Access Compliance Report

Public Rights-of-Way

Intersection ID: 25759	Main Street: PLANTERS RIDGE RD	Cross Street: PROVIDENCE VIEW LN	Location: NW
ADA ID: A2ECD647AF67	Ramp Type: BlendTrans1	Initial Pass/Fail: Fail	Overall Compliance: No
		Severity Score: 35

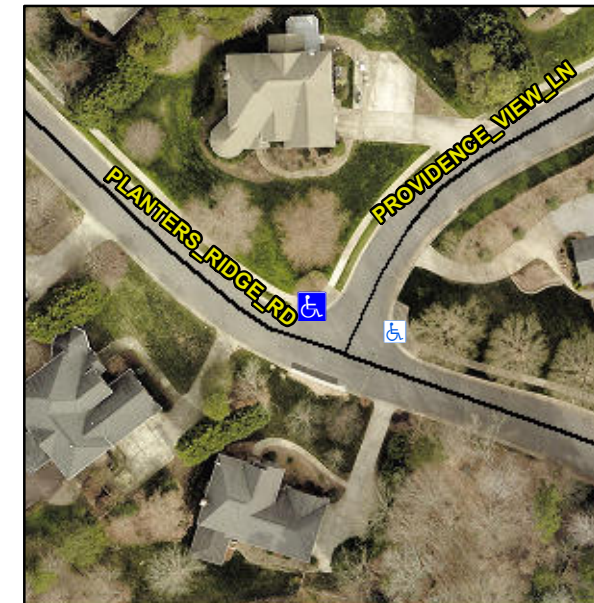
Not Found, R304.5.1

Compliance	Description	Data	Compliance	Description	Data
N/A	Ramp Length (in)	95.0	Yes	BlendTrans Slope (%)	2.6
No	Ramp Width (in)	28.0	Yes	BlendTrans XSlope (%)	0.3
N/A	Flare Type LT	N/A	N/A	Flare Type RT	N/A
N/A	Flare Slope LT (%)	N/A	N/A	Flare Slope RT (%)	N/A
N/A	Flare Traversable LT?	N/A	N/A	Flare Traversable RT?	N/A
N/A	Landing Length (in)	N/A	N/A	DWS Provided?	N/A
N/A	Landing Width (in)	N/A	N/A	DWS Contrast?	N/A
N/A	Landing Slope (%)	N/A	N/A	DWS Length (in)	N/A
N/A	Landing X Slope (%)	N/A	N/A	DWS Full Width?	N/A
N/A	Landing Curb? (Y/N)	N/A	N/A	DWS Offset (in)	N/A
N/A	Shared Landing?	N/A			
N/A	Gutter Ponding?	N/A	N/A	Gutter Slope (%)	N/A
N/A	Gutter Lip Ht (in)	N/A	N/A	Gutter X Slope (%)	N/A
N/A	Painted X Walk1?	No	N/A	Painted X Walk2?	N/A
	X Walk 1 Direction	To E		X Walk 2 Direction	N/A
	X Walk 1 Width (in)	N/A		X Walk 2 Width (in)	N/A
	X Walk 1 Slope (%)	2.6		X Walk 2 Slope (%)	N/A
	X Walk 1 X Slope (%)	2.2		X Walk 2 X Slope (%)	N/A

N/A	Ramp inside XWalk1?	N/A	N/A	Ramp inside XWalk2?	N/A
	Road Slope (%)	2.2		Clear Space?	N/A
	Road X Slope (%)	2.6	N/A	Clear Space to XWalk (in)	N/A
N/A	Any Obstructions?	N/A	N/A	Storm Grate/Utility Hazard?	N/A
	Obstruction Type			Storm Grate/Utility Type	
		N/A			N/A
			Yes	Surface Condition? (G/P)	Good
			No	Curb Slope (%)	11.8

Remove & Replace Curb Ramp With Two New Directional Ramps or Equivalent.
